NINE MILE POINT NUCLEAR STATION-UNIT 2
NIAGARA MOHAWK POWER CORPORATION
I.O. No. 12177-P.O. No NMP2-P223E

NO. UNITS REQ'D		CUST. DWG. OR SPEC.	
CUSTOMER ORDER NO.		CUST. TAG OR ITEM NO.	
NMP2-P223E			
RICHMOND ENGINEERING CO., INC. RICHMOND VIRGINIA			
NOTES			
NIAGARA MOHAWK/STONE & WEBSTER			
REV. NO.	CHANGE NOTICE NO.	DESCRIPTION	BY DATE
1		AS SHOWN	5/16/78
2		THRU	5/16/78
3		BT	5/16/78

STONE & WEBSTER ENGINEERING CORPORATION NINE MILE POINT NUCLEAR STATION - UNIT 2 NIAGARA MOHAWK POWER CORPORATION I.O. 12177			
INSTRUCTIONS TO SUPPLIER (E2)			
APPROVED		AS DEFINED IN SPECIFICATION	
APPROVED AS REVISED			
RELEASED FOR FABRICATION			
RELEASED FOR MATERIAL PURCHASE			
SUPPLIER TO RESUBMIT	Q	REVISOR	REVISED PRINTS
	N	1	REPRODUCIBLE
	T		FOR REVIEW
			FOR RECORD
NONE REQUIRED			
NOTES:			
(E1) FOR INFORMATION ONLY RETURN TO SUPPLIER NOT REQUIRED			
INSTRUCTIONS TO DESIGN ENGINEER (E1)			
I-O	P-L	P-S	R-C F-D NEW REV
DESIGN ENGINEER'S DATE STAMP (D)			
OUT.			
INITIALS OF SELECTED REVIEWERS			
RESPONSIBLE ENGINEER'S DATE STAMP (E2)			
NOTED MAY 1 1984 L.L. 3000			
SUPERSEDES S & W FILE NO. (E1) (25-34) (35-38)			
REMARKS (C) (LIMIT TO 22 CHARACTERS & BLANKS) (33-74)			
S & W EQUIP. I

FLANGE DETAIL FOR H3

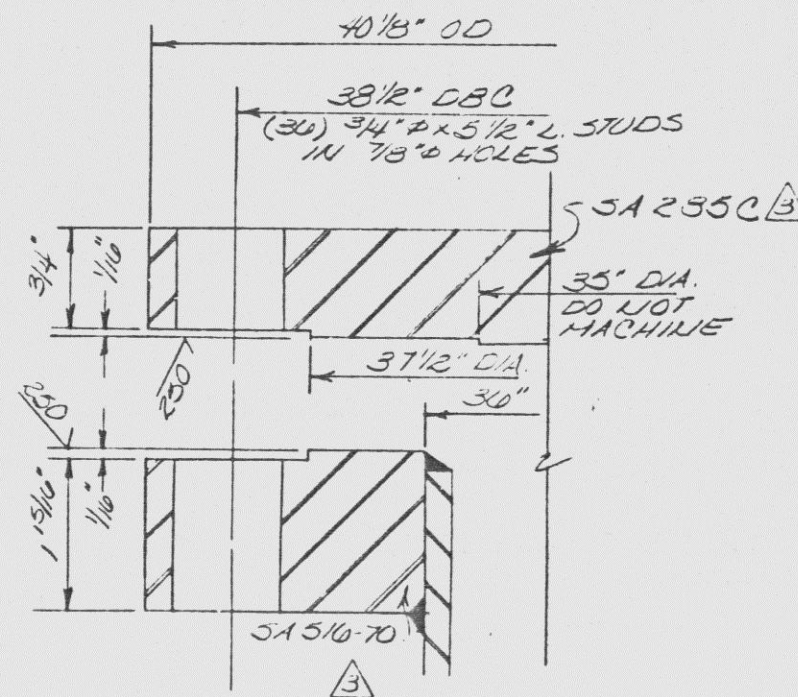
UPDATE
